ZURI HYBRID VTOL ANNOUNCED CONSTRUCTION UPDATES

News / Business aviation, Manufacturer

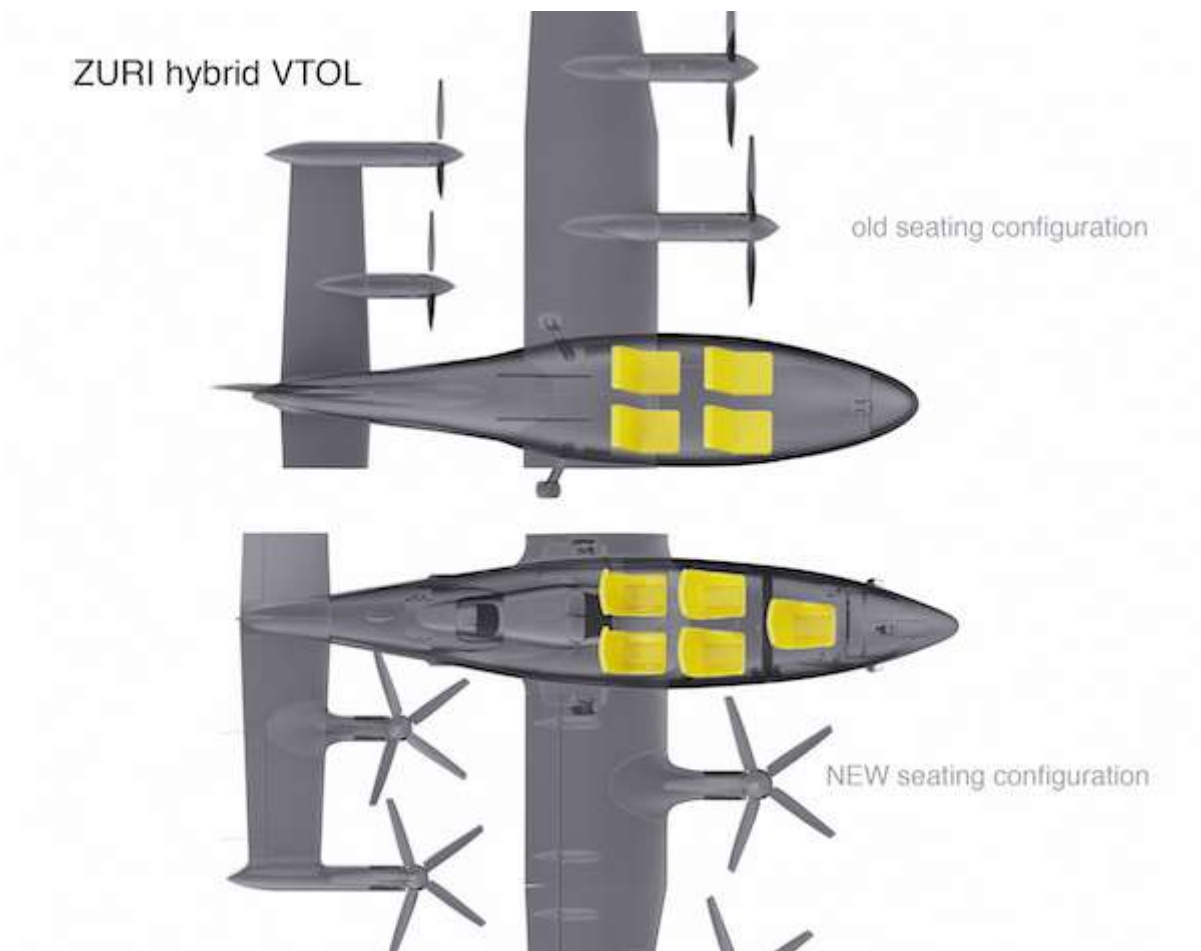
From the outside, the most significant change has been made at the aircraft's rear. Here, instead of a standard tail with the vertical stabilizer, there is now a V Tail.

Such design change will allow for larger propellers and a further increase in the distance between propellers and the ground. Furthermore, using a V Tail should result in lower aerodynamic drag and help in the plane's overall aerodynamics characteristics.
